Updating a Rev 4 Motherboard

There were several errors on the Rev 4 SS-50 motherboards that prevent them from using interrupts in most cases. This doesn't affect most Flex users because Flex uses polled I/O, but this can prevent NitrOS-9 from running since it uses interrupts for several features. There is a modification to fix the problem; once this is done, the motherboard is technically a revision 4A motherboard. As of now, there is no revision 5 with all the fixes applied.

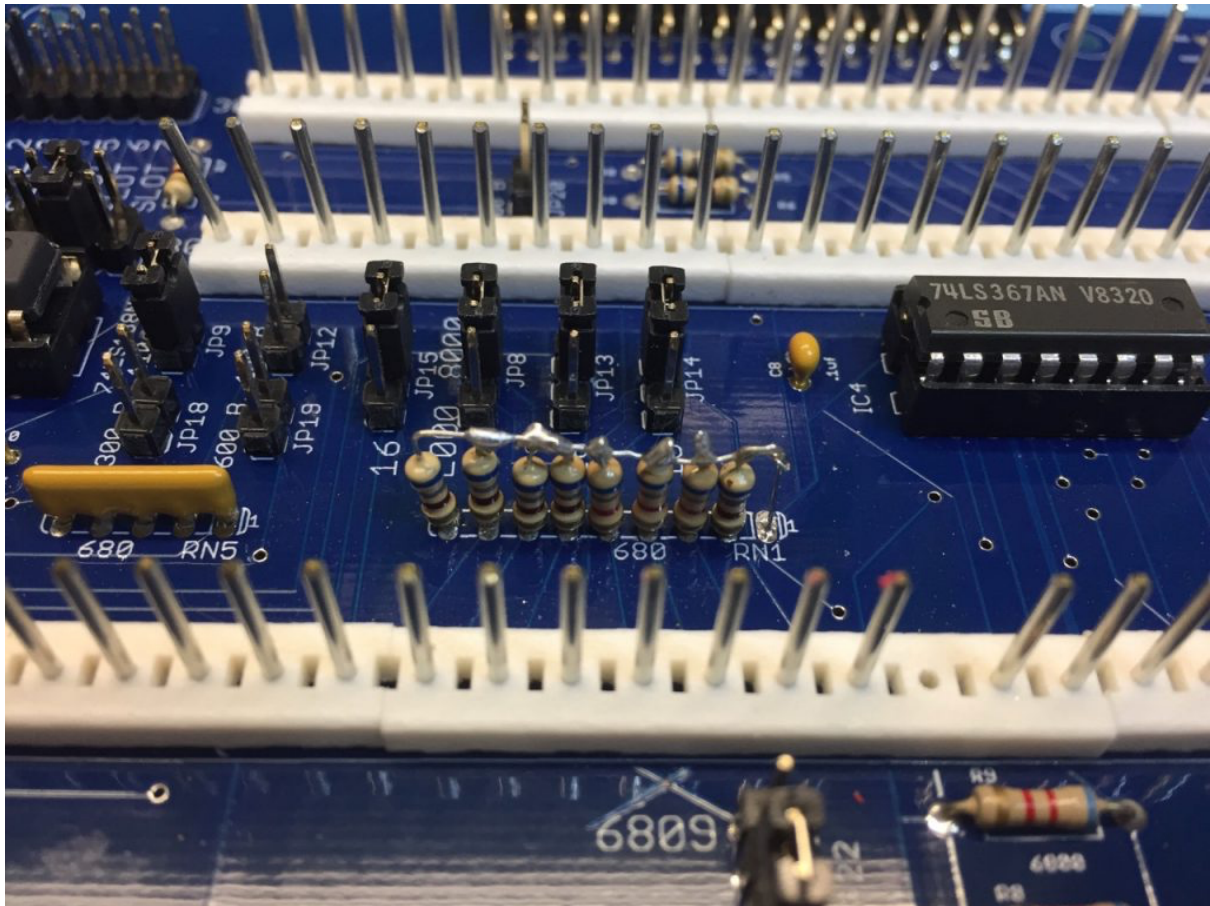
On the Rev 4 motherboard, RN1 is a resistor network of 680 ohms each. This device needs to be removed, five of the resistors replaced with 680 ohm resistors, and three replaced with 6.8K ohm resistors. There is also a short jumper to install on the bottom of the board.

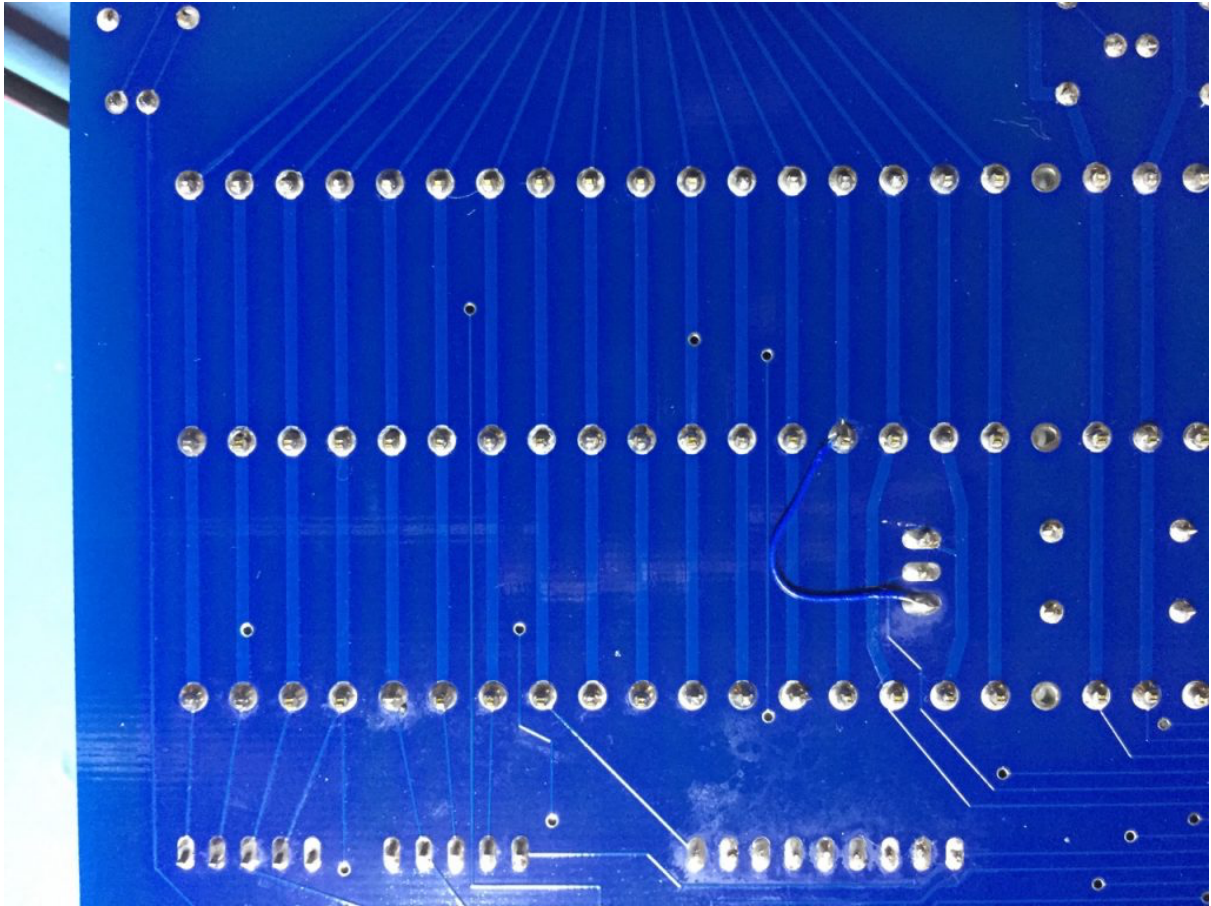
Going from the left-most position, the resistors are 680, 680, 680, 680, 6800, 6800, 6800, 680. Ie, four 680 in a row, then three 6800, then one more 680.

Solder each resistor vertically in place, leaving the long lead on the top. Once all are in, bend the right-most top pin and insert it into the first position. Solder that in place. Now just bend the leftmost top lead over, solder all the top leads to the one going back to the first position. I'm sure my description isn't good, but the picture should explain it.

Again, refer to the picture above and cut the trace just above the "6809" silkscreen that goes to JP22.
